Ser. No. 10/519,028
Amdt. dated November 14, 2008
Reply to Office action of June 30, 2008

Amendments to the Drawings

Remarks/Arguments

FIG. 1

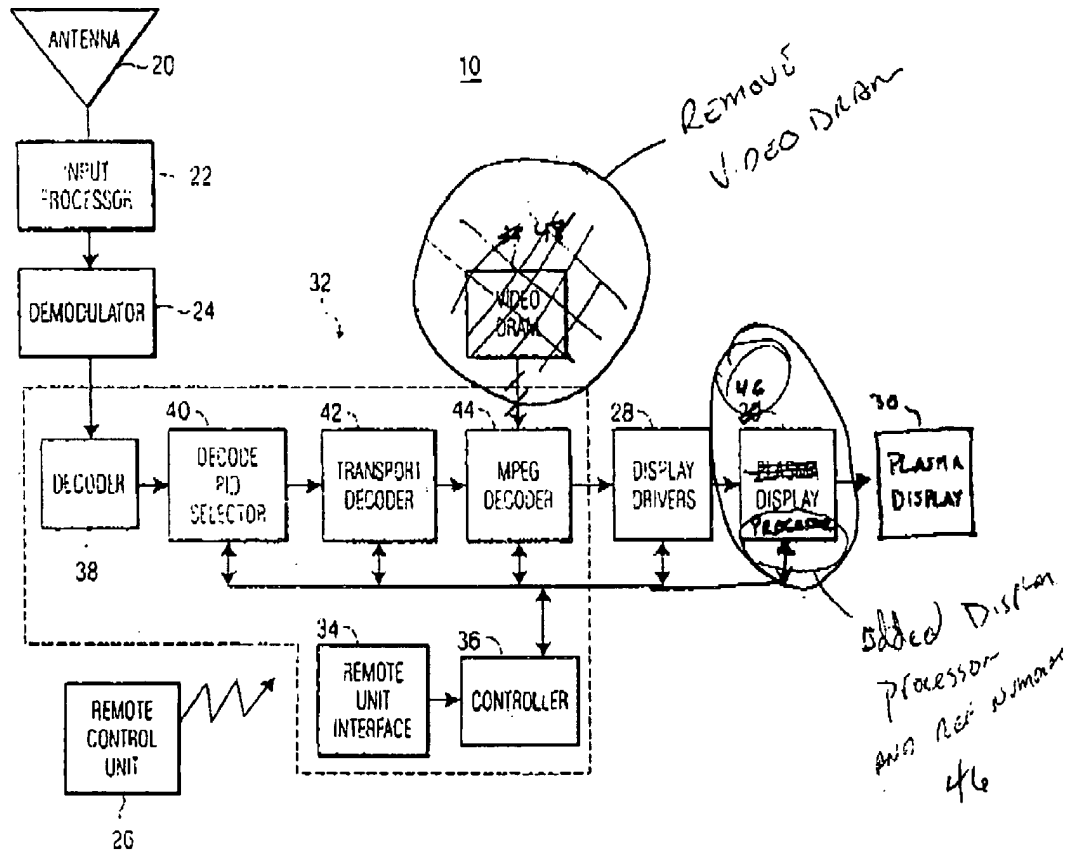
The attached sheets of drawings include changes to Figs. 1-2. These sheets, which include Figs. 1-2, replace the previously filed replacement sheets including Figs. 1-2. In Figure 1, previously omitted element 46, described on page 7 of the specification, has been added and the duplicate use of label 44 has been corrected. In Figure 2, previously omitted element labels 61 and 69 have been added.
